Traffic Impact Assessment

SSDA FOR BUILDING B AT
MACQUARIE MPARK, RESPONSE TO
TRAFFIC MATTERS RAISED BY
AUTHORITIES

FEBRUARY 2021

Upgrade of Talavera Road /
Khartoum Road Intersection

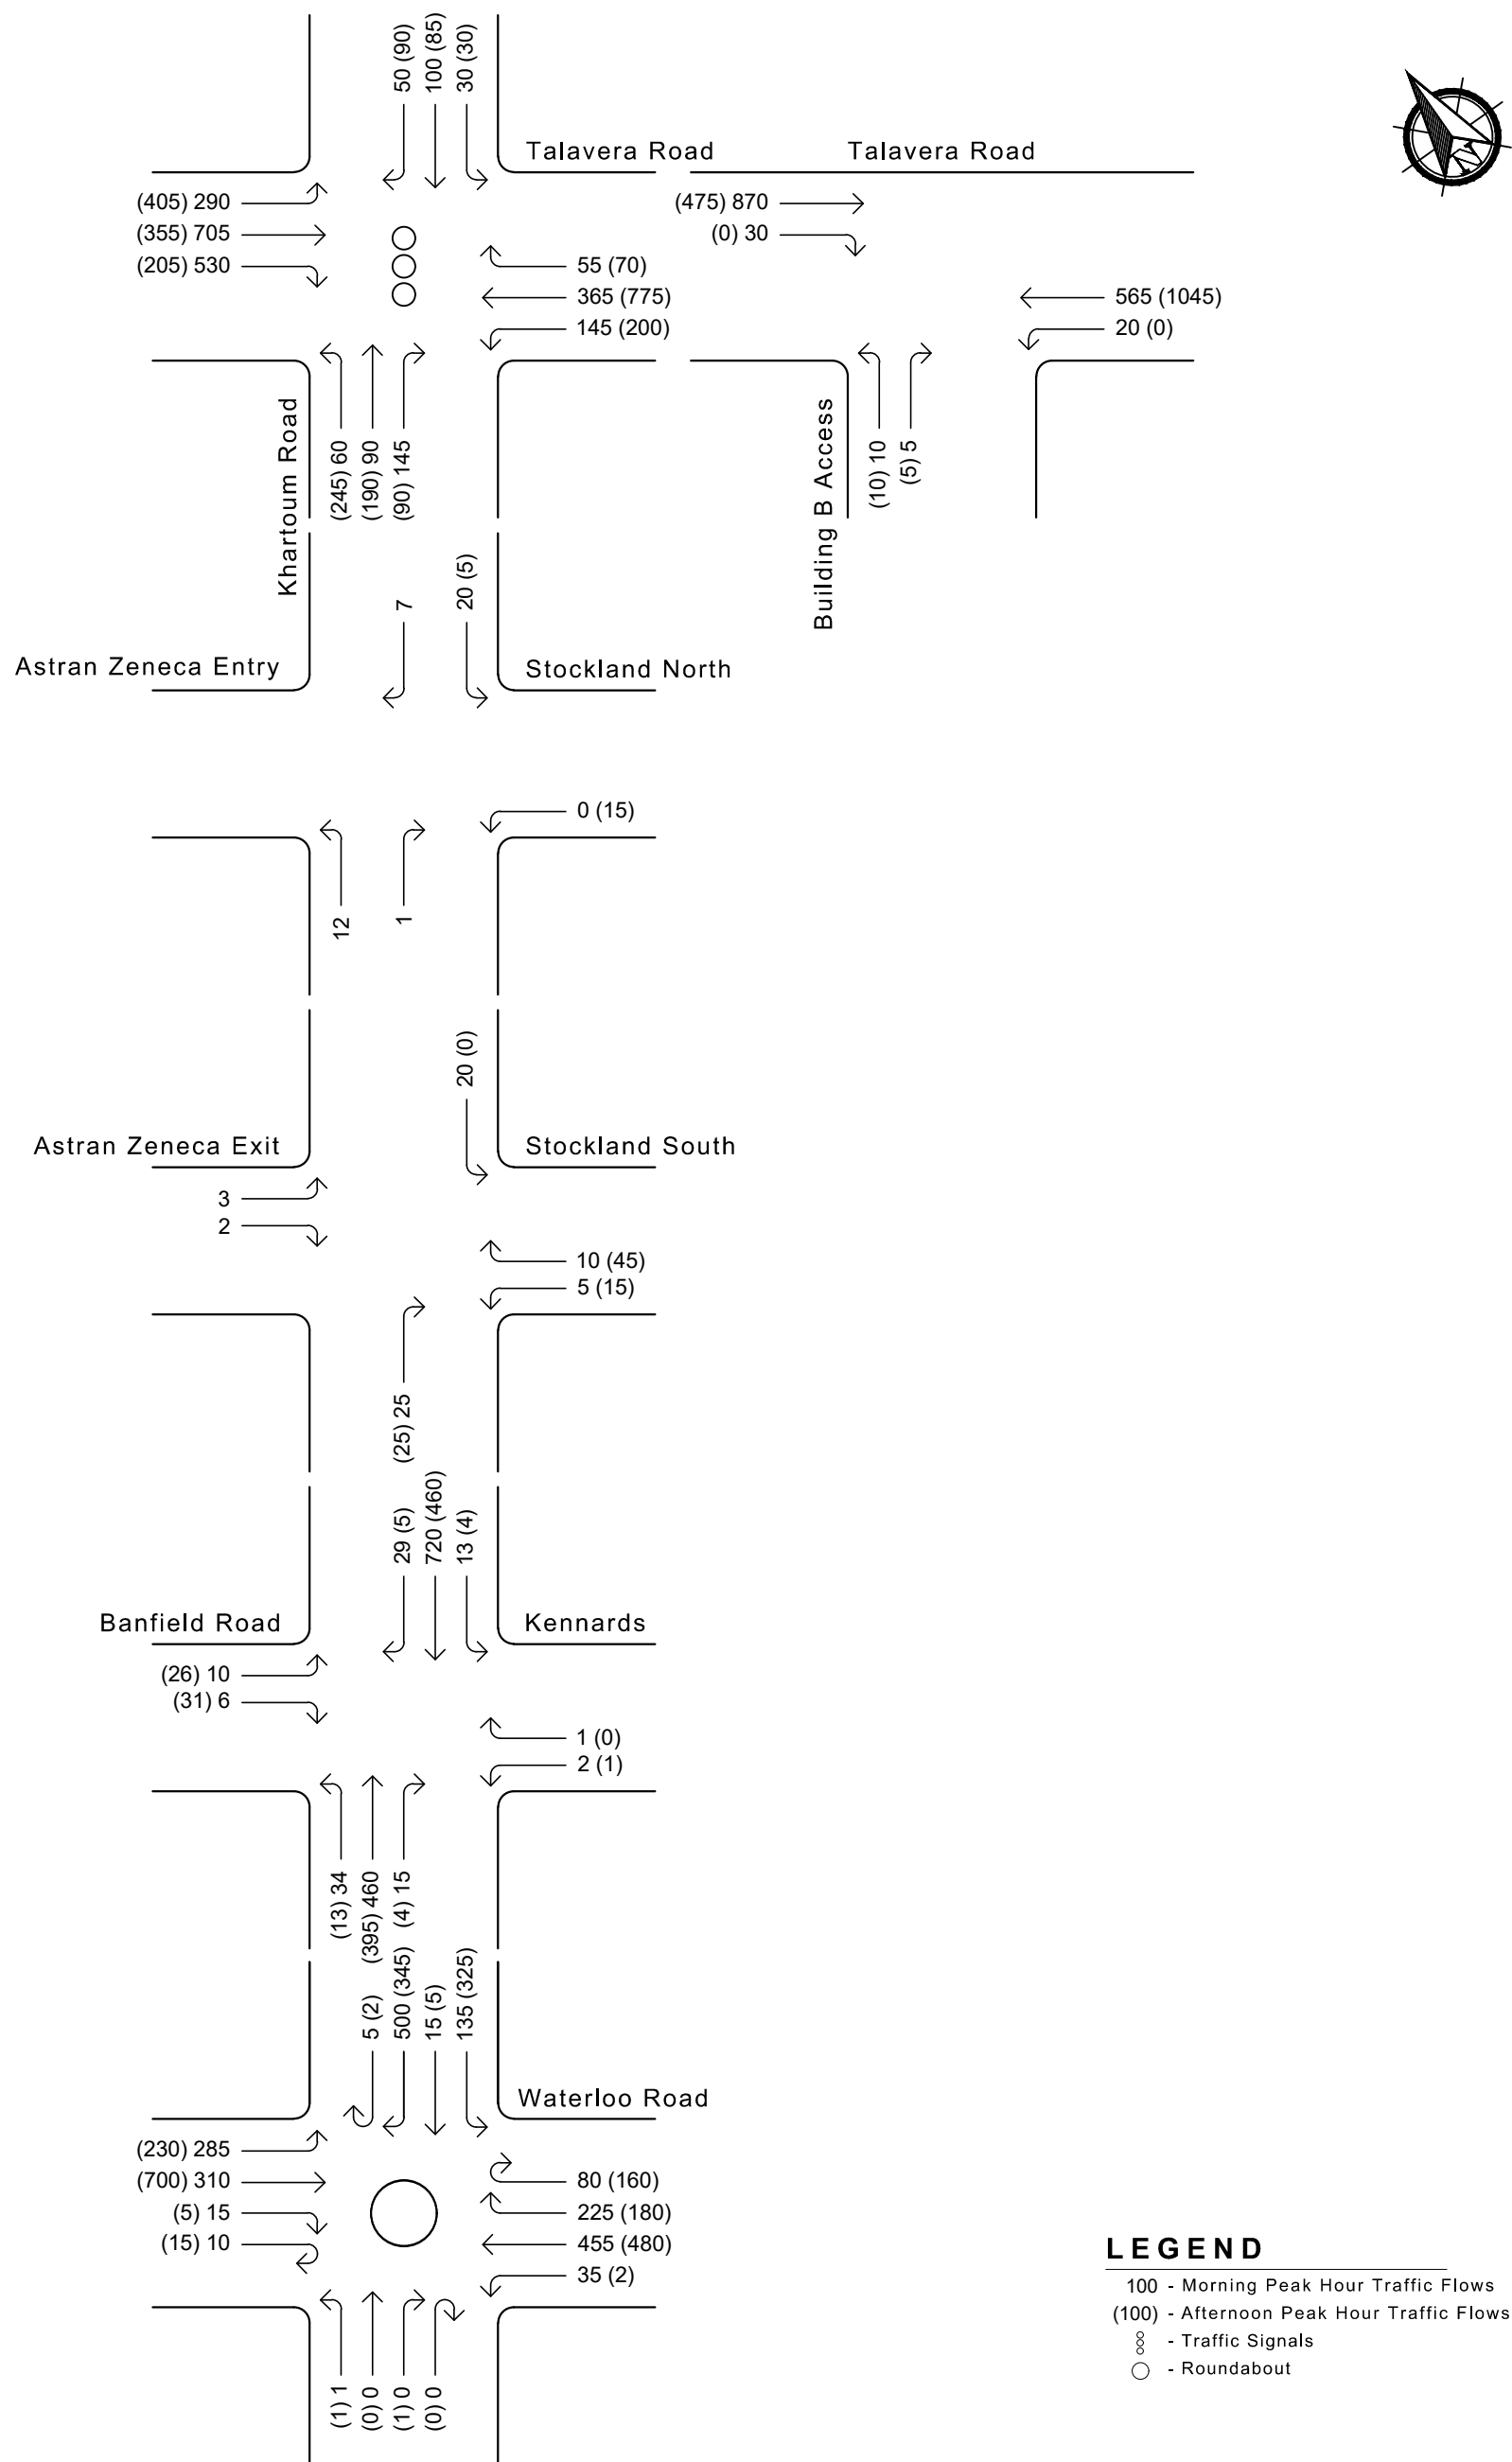
The future public road junction of Road 22 with Talavera Road, which will primarily service the data centre in the interim period is projected to operate with a poor level of service due to significant delays experienced by right turning vehicles exiting from Road 22 onto Talavera Road. The EIS is incorrect in stating that the data centre development will have negligible impact on this intersection. It is noted that the 2018 traffic study recommended access movements at this future road intersection be restricted to left in/left out. This measure will mean people travelling to the site from the west and departing the site to the east via Road 22 would be required to circulate within the local roads for longer periods to access the data centre site, which can lead to greater inconvenience to drivers to the site. An updated traffic assessment is therefore required to evaluate the merit of this intersection control and/or provide any alternative treatments that would result in a better traffic outcome for the intersection. The civil drawings need to be amended to reflect the design of future traffic control arrangement at the intersection of Talavera Road and Road 22.

1.2 At a meeting on 11 February 2021, TfNSW advised that the upgrade of the intersection of Talavera Road/Khartoum Road was not included in any current works program. On this basis, TfNSW requested that an assessment of the operation of the intersection without any upgrade be included in this traffic assessment. TfNSW also advised at the meeting that no contribution from Building B to the upgrade of the intersection would be required as:

- by 2031, the intersection of Khartoum Road/Talavera Road be upgraded as per the plan prepared by TfNSW (Figure 2) and that Stockland has entered into a transport infrastructure contribution agreement with TfNSW for \$600,000 for Building A. TfNSW advised at a meeting on 11 February 2021 that the upgrade of this intersection is not in any current works program;

- 2.11. As requested by TfNSW the operation of the intersection of Talavera Road/Khartoum Road in 2031 without any upgrade has also been undertaken.

- the intersection of Khartoum Road/Talavera Road (without intersection upgrade) would operate with average delays of greater than 70 seconds per vehicle in the weekday morning peak period. This represents level of service F, an unsatisfactory level of intersection operation. In the weekday afternoon peak period, the intersection would operate with average delays of less than 50 seconds per vehicle. This represents level of service D, a satisfactory level of intersection operation;

- ❑ the intersection of Khartoum Road/Talavera Road would operate with average delays of some 42 seconds per vehicle in the weekday morning and afternoon peak periods. This represents level of service C, a satisfactory level of intersection operation;
 - ❑ the intersection of Khartoum Road/Talavera Road (without intersection upgrade) would operate with average delays of greater than 70 seconds per vehicle in the weekday morning peak period. This represents level of service F, an unsatisfactory level of intersection operation. In the weekday afternoon peak period, the intersection would operate with average delays of less than 60 seconds per vehicle. This represents level of service E, at capacity;
-

- 2.22 Therefore the surrounding road network (with the upgrade of the intersection of Khartoum Road/Talavera Road) would be able to cater for the additional traffic generated by the development (Buildings A, B, C and D). Without the upgrade of the intersection of Khartoum Road/Talavera Road, with the exception of this intersection, the surrounding road network would be able to cater for the additional traffic generated by the development (Buildings A, B, C and D). The intersection of Khartoum Road/Talavera Road would operate at capacity.
- 2.23 An assessment of queuing in Khartoum Road in 2031 has been undertaken with development (Buildings A, B, C and D) traffic in place. Table 2.2 below summarises SIDRA analysis 95% back of queues (with right turns at the southern site access) on Khartoum Road from the intersections with Talavera Road and Waterloo Road.

2.1 With regards to upgrading of the intersection of Talavera Road and Khartoum Road, TfNSW advised at the meeting on 11 February, 2021 that no contribution from Building B would be required as:
